**Fourth Interim Collection
1991–1993 NESC Interpretations**

National Electrical Safety Code Committee, ASC C2

**Fourth Interim Collection
of the
National Electrical Safety Code
Interpretations**

Fig IR 470-1 (a) - (d)

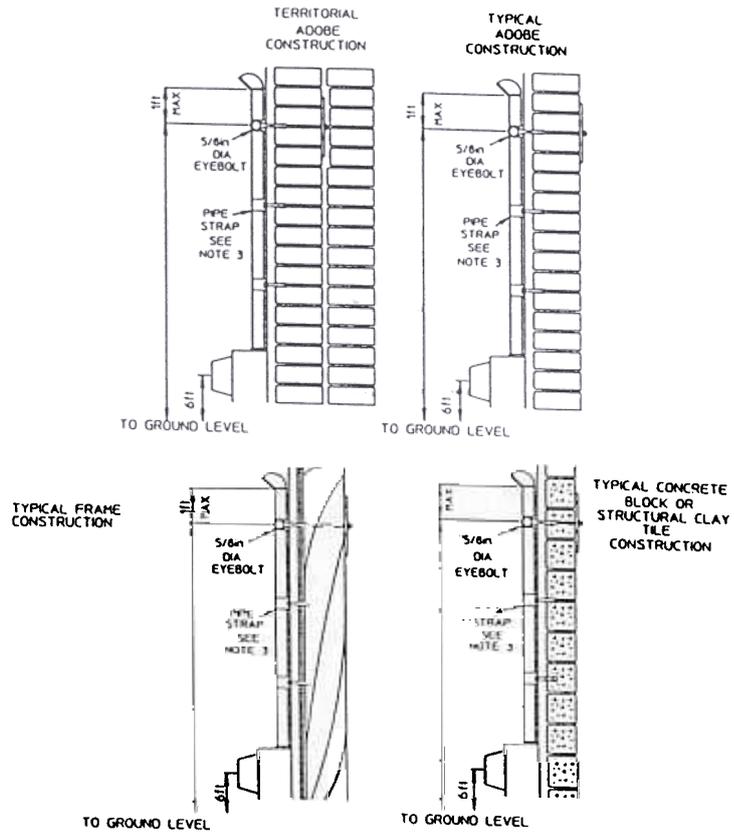
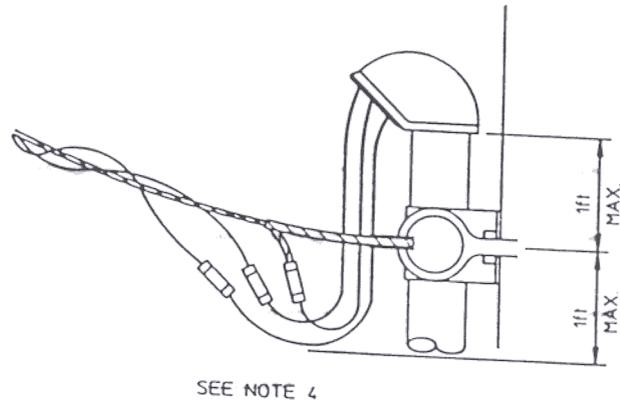
Our public service company uses an insulated triplex service cable for 120/240 volt service to homes. The cable meets the requirements of Rule 230C3. We allow for a 1 ft drip loop below the service point of attachment to a single family residence as shown in Figs IR 470-1 (a) through (d) and 470-2.

On new construction, we could require the point of attachment to be at elevation 13.0 ft so that the drip loop height is 12.0 ft in order to comply with the 12.0 ft in category 5 of Table 232-1. Alternatively, we could require that point of attachment at 11.5 ft so that the service drop and drip loop comply with Table 232-1, items a and c in Footnote 8.

Clarify the meaning of *does not permit*. This could mean anything from inconvenient to economically burdensome to almost impossible. Is it the intent of the NESC to routinely allow or condone a drip loop clearance of 10.5 ft, as is allowed by the 1993 National Electrical Code (NEC) in 230-24?

The answer to your question is no, it is not the intent of the NESC to *routinely* allow or condone the reduced clearances stated in Footnote 8 of Table 232-1.

Application of Footnote 8 is limited to cases “where the height of attachment to a building. . . does not permit service drops to meet these values. . .” (as given in Table 232-1, Item 5). Table 232-1 clearances are required if the building being serviced is high enough so that the attachment may be made to the building without the need for a service mast (such as two-story or gable-roofed houses). Footnote 8 may be used *with discretion* on low buildings (such as flat or hip-roofed houses), either to avoid the use of a service mast or to limit the height of a mast where a mast is necessary.

Figs IR 465-1 and IR 465-2

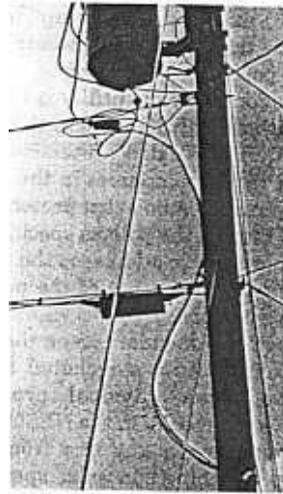
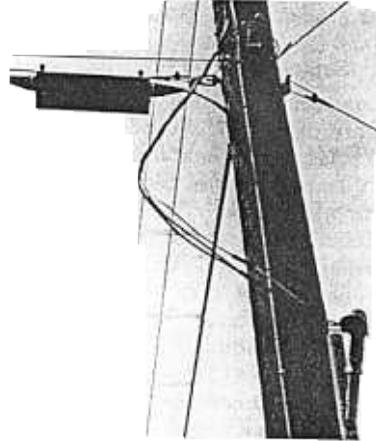
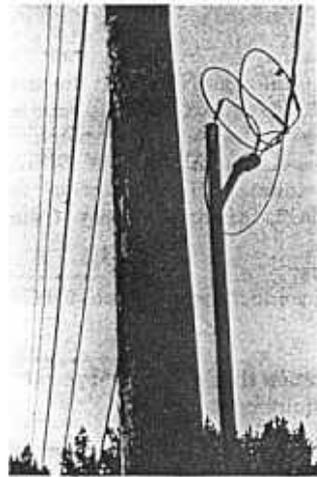
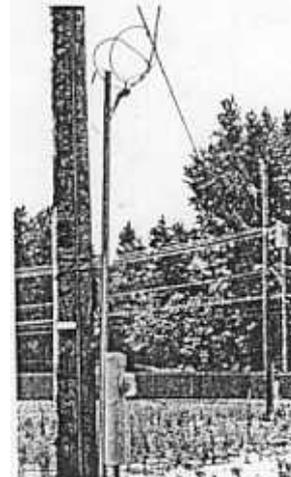
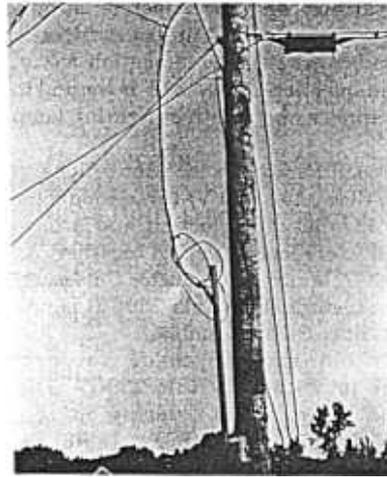
The enclosed photographs (Figs IR 465-1-465-6) depict typical temporary power installations throughout the area concerned consisting of triplex conductors suspended freely from the transformer secondary splice to the weatherhead placed toward the bottom of the pole. As you can see, the conductors are somewhat loose in the climbing space and, according to some, create a considerable exposure hazard to those climbing with "hooks." One photo (Fig IR 465-3) exhibits an attempt by a communications worker to tie back the triplex so that it would not be adjacent to his working area on the pole.

The position of the local electric utility is that these installations are in accordance with the NESC rules in that the multiconductors are jacketed and require no extra protection as specified in Rule 239G2. The communication companies in the area believe that if in fact this service drop requires no extra protection, it still would require being fastened taut on the pole as specified in Rule 239G4b. It also appears that Rule 239E2c addresses the issue of attaching the secondary conductors to the surface of the pole. The local electric utility does not agree with this.

1. Does Triplex constitute a jacketed multiconductor cable requiring no extra physical protection in vertical installations as referred to in the NESC Rule 239G2?
2. Is Triplex exempted in any way from being securely fastened through climbing spaces as specified in NESC Rules 239E and 239G?

3. Are the construction methods depicted in Figs IR 465-1–465-6 in accordance with NESC rules and regulations?

This request for interpretation concerns electric supply conductors in the climbing space of jointly used utility structures. Rule 239G, covering supply conductors in communication space, appears to be the primary rule in question. Rule 239E is limited to supply space, and Rule 239G4b applies only to street lighting lamp leads.

Triplex, as used in this IR and as illustrated in the photographs, is a generic term for a low-voltage (less than 600 V) three-conductor supply cable consisting of two insulated conductors and a bare neutral, with the individual conductors loosely cabled together. As such, it is covered under Rule 239G7, Multiple-Conductor Cables. In contrast, a jacketed multiple-conductor cable (Rule 239G2) is one with a single jacket enclosing the entire cable assembly.

Vertical runs of *triplex* cable may be made through communication space under the provisions of Rule 239G7. The cable must be protected by a nonmetallic covering in the communication space (see also IR 439 — March 22, 1990). In addition, the triplex cable must be attached to the structure through the entire communication working space; it may not leave the structure as an aerial service with 40 in above or below communication attachments.

It should be noted that vertical runs may not obstruct either the climbing or the working space, nor may they interfere with the safe use of pole steps (Rules 237C and 239B). Also, vertical cable runs in the climbing space must be both securely attached to the structure and protected with nonmetallic covering (Rule 236H). While *jacketed* cables do not require nonmetallic protection in communication space under Rule 239G2, this applies only if the vertical run is not in the climbing space.

1. Triplex is not a jacketed multiconductor cable; Rule 239G2 does not apply.
 2. No.
 3. The photographs show construction that does not appear to be in accordance with NESC requirements.
-

Fig 472-
Moonlight Tower

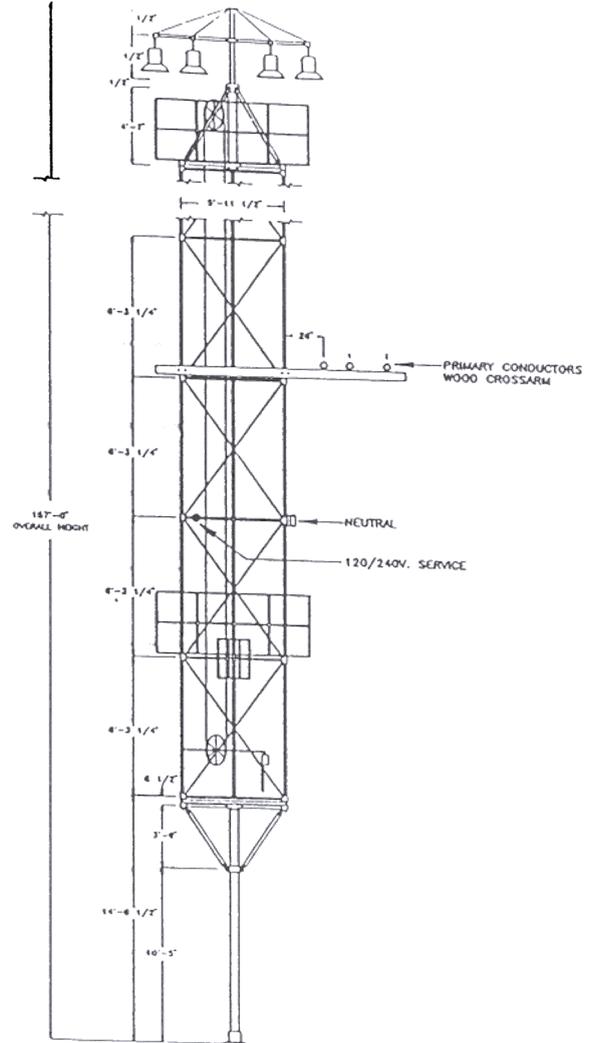
The structure in question is shown in Fig 472-1. This structure was constructed in 1894 to provide area lighting. Additionally, over the past thirty years, it has been utilized as a supporting structure for a three-phase 15 kV distribution line in a residential area. This was accomplished by bolting a spool insulator for the neutral conductor and a cross arm for the three primary conductors to two of the vertical members of the lattice structure.

1. Does this structure meet the definition of a "readily climbable" structure?
2. Is this structure a "closely latticed pole or tower"?
3. Does the proximity of the stop sign as shown in Fig 472-3 modify your interpretation if it is possible for the stop sign to be used to access the upper lattice area of the structure?

Fig 472-2
Column Base Elevation

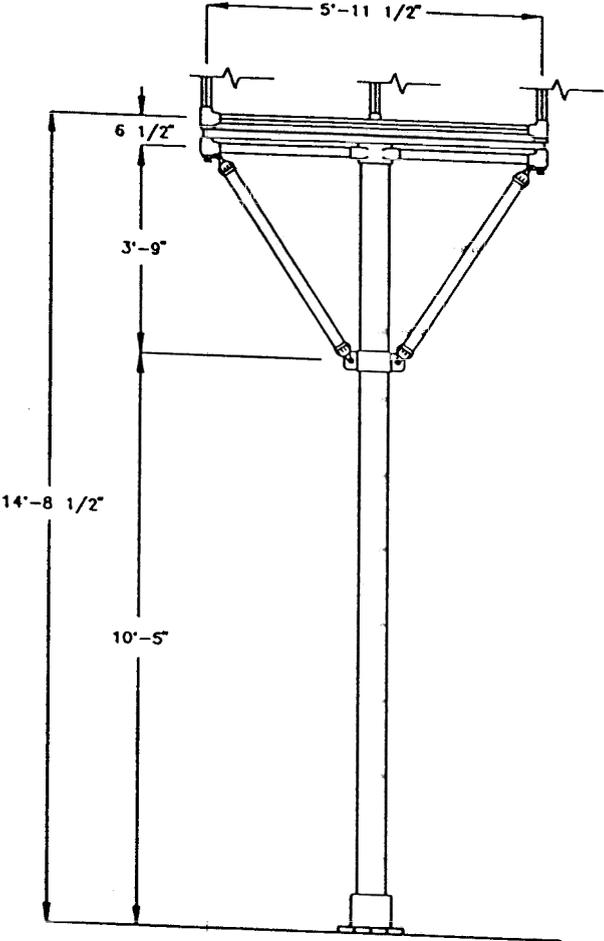
In Fig 472-2, the lattice-type structure supported by a single tubular steel support is shown. The tubular support is approximately 24 1/4 in in diameter. The distances from ground level to the bottom of the support arms and additional distance to the first horizontal cross member are noted.
